Reference: Second Independent Supplemental Peer Review for *Emerson Homes*  
Chapter 40B Comprehensive Permit Application  
10 High Street  
Topsfield, Massachusetts  
B+T Project No. 3425.00

Beals and Thomas, Inc. (B+T) is pleased to assist the Town of Topsfield Zoning Board of Appeals (the Board) with the second independent Supplemental Peer Review of the Chapter 40B Comprehensive Permit Application Filing for “Emerson Homes” at 10 High Street in Topsfield, Massachusetts (the Site). We understand that Emerson Homes, LP (the Applicant), proposes to develop a Chapter 40B housing project consisting of 44 apartment units (43 designated as affordable and one market-rate), with associated site improvements (the Project).

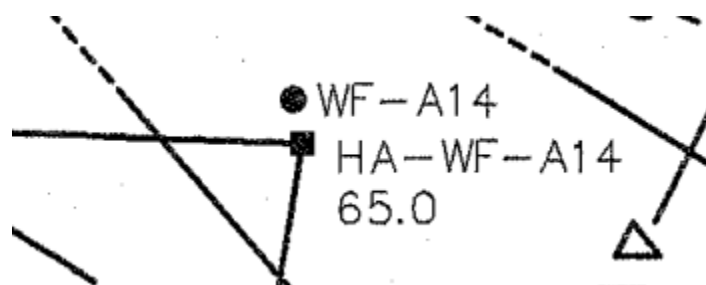
31. The WF-E Series wetland and its Buffer Zone are not depicted in the Plan except for the Existing Conditions sheet. Although we understand that it is the Applicant's intent to request a waiver from the local jurisdictional status of this resource area, we request that it be depicted on the Plan for review purposes. Given that it is referenced as a 'By-Law Hydric Soil Wetland' on the plan, we also request that the Applicant address how filling areas of hydric soil may affect the connected state jurisdictional wetlands, particularly the adjacent vernal pool.

*Applicant's Response: For clarity, a second plan has been provided (Plan C-2A) that shows the requested resource lines and local jurisdictional buffers in context to the design for reference. The hydric soil/topsoil within construction areas will be removed. These areas are at the edge of the buffers and will not impact the resource areas.*

**B+T Current Response: The Local 200-foot Riverfront Area has been added to Plan C-2A but not the E Series Hydric Soil wetland as requested. As the Applicant indicates that 'hydric soil/topsoil' will be removed from the construction area, we further request that the Applicant provide the Board with information as to how potential weeping of groundwater will be addressed as hydric soils are removed from the proposed limits of disturbance.**
